SERVICE LETTER 213

FIRE BOSS FINLET ATTACH BOLTS REINSTALL

Aircraft Makes/Model(s):	Float Model(s):	Compliance: Mandatory	By: MAB
Air Tractor AT-802 & AT-802A	10000A	Part Number: 1011544	Approved: SDW
		Date: 7/29/2020	Revision: A

Figure 1

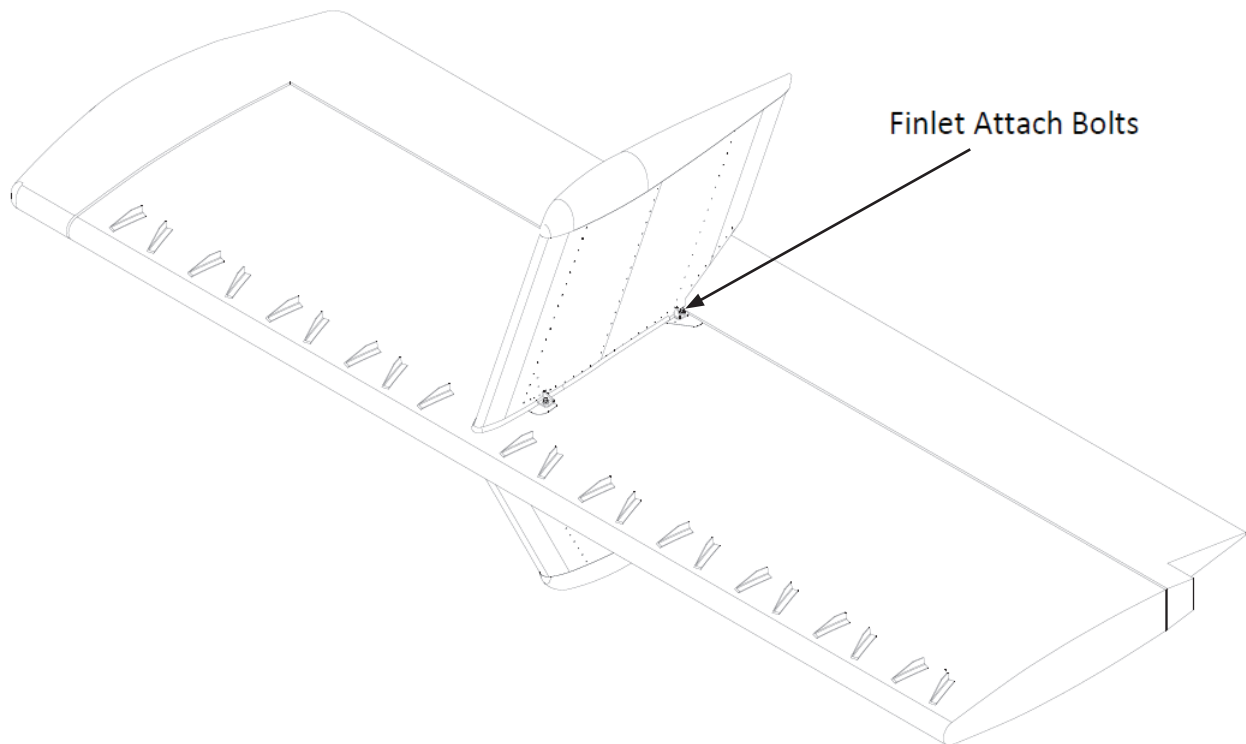
It is possible that the locking feature of the Fire Boss finlet bolt attach nutplates can become degraded. This service letter adds medium strength Loctite 242 (or equivalent thread locker) to the bolt installation as a secondary locking mechanism.

1. For all 4 finlets (top and bottom, LH/RH side): Remove and reinstall the ¼" attach bolts into the nutplates of the horizontal tail.
 - a. Apply Loctite 242 or equivalent thread locker (medium strength) to the bolt when reinstalling.
 - b. Torque the attach bolts in a range from 50 in-lbs. to 70 in-lbs.
 - c. Apply Torque Stripe.

WARNING: In order to maintain the locking feature of the nutplate, DO NOT RUN A TAP into the nutplate.
